HISTORIC AND DESIGN REVIEW COMMISSION

March 06, 2019

HDRC CASE NO: 2018-619
COMMON NAME: 416 KENDALL
LEGAL DESCRIPTION: NCB 1742 BLK 15 LOT S 50 FT OF 1 & 2
ZONING: IDZ,H
CITY COUNCIL DIST.: 1
DISTRICT: Tobin Hill Historic District
APPLICANT: Joseph Smith/JMS Architects
OWNER: Wendell Farish
TYPE OF WORK: Construction of a 2 1/2-story single family structure with attached garage
APPLICATION RECEIVED: February 15, 2019
60-DAY REVIEW: April 16, 2019
REQUEST:

The applicant is requesting final approval to construct a 2 1/2-story single family structure with a 1-story connected garage.

A3.0

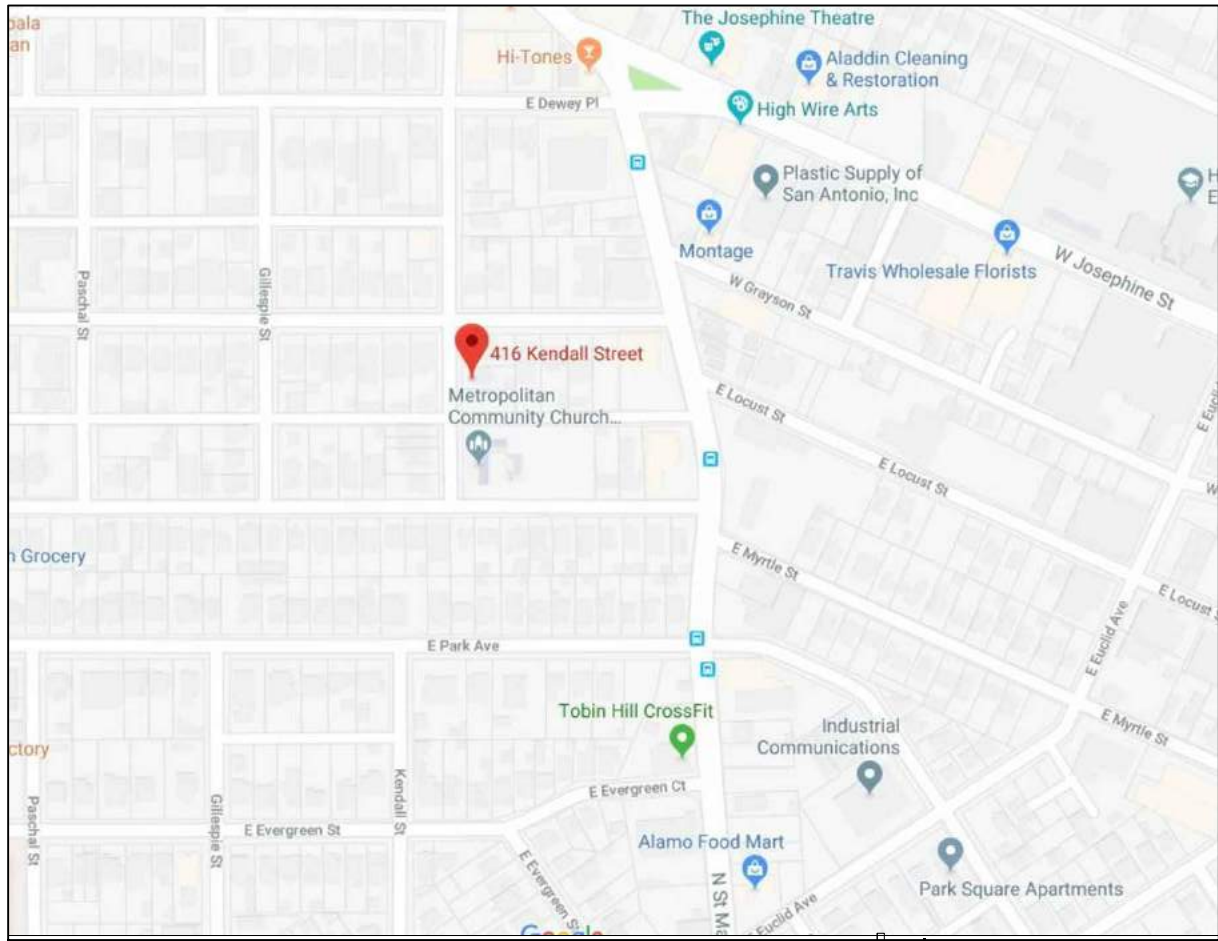
- i. That the applicant reduces the amount of metal siding on the primary structure, especially in highly visible locations, as noted in finding m. The applicant is required to submit updated elevations and a final material

specification to staff prior to receiving a Certificate of Appropriateness. The specifications should indicate the installation method and dimensions of the product.
